PIC16(L)F1934/1936/1937 Family Silicon Errata and Data Sheet Clarification

The PIC16(L)F1934/1936/1937 family devices that you have received conform functionally to the current Device Data Sheet (DS41364E), except for the anomalies described in this document.

The silicon issues discussed in the following pages are for silicon revisions with the Device and Revision IDs listed in [Table 1](#). The silicon issues are summarized in [Table 2](#).

FIGURE 1: INSTRUCTION CYCLE DELAY CALCULATION EXAMPLE

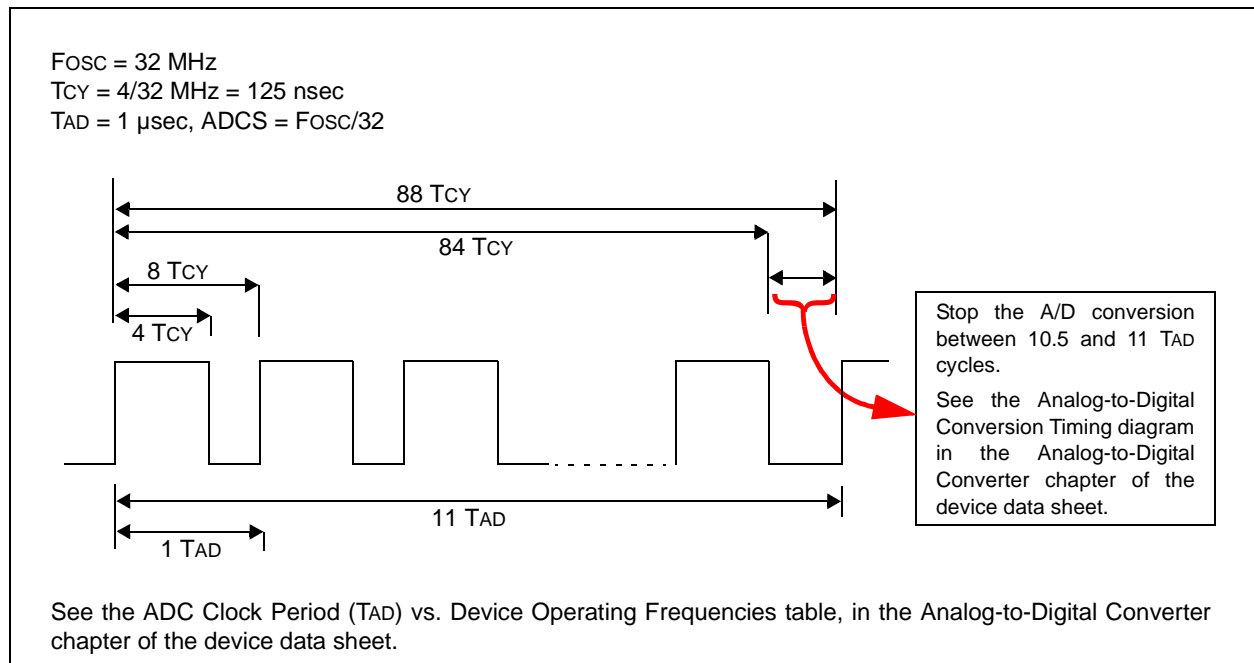
An ADC conversion may not complete under these conditions:

1. When F_{OSC} is greater than 8 MHz and it is the clock source used for the ADC converter.
2. The ADC is operating from its dedicated internal FRC oscillator and the device is not in Sleep mode (any F_{OSC} frequency).

When this occurs, the ADC Interrupt Flag (ADIF) does not get set, the $\overline{GO/DONE}$ bit does not get cleared, and the conversion result does not get loaded into the ADRESH and ADRESL result registers.

Method 3: This method is provided if the application cannot use Sleep mode and requires continuous operation at frequencies above 8 MHz. This method requires early termination of an ADC conversion. Provide a fixed time delay in software to stop the A-to-D conversion manually, after all 10 bits are converted, but before the conversion would complete automatically. The conversion is stopped by clearing the $\overline{GO/DONE}$ bit in software. The $\overline{GO/DONE}$ bit must be cleared during the last $\frac{1}{2}$ TAD cycle, before the conversion would have completed automatically. Refer to [Figure 1](#) for details.

In [Figure 1](#), 88 instruction cycles (TCY) will be required to complete the full conversion. Each TAD cycle consists of 8 TCY periods. A fixed delay is provided to stop the A/D conversion after 86 instruction cycles and terminate the conversion at the correct time as shown in the figure above.

Note: The exact delay time will depend on the TAD divisor (ADCS) selection. The Tcy counts shown in the timing diagram above apply to this example only. Refer to [Table 3](#) for the required delay counts for other configurations.
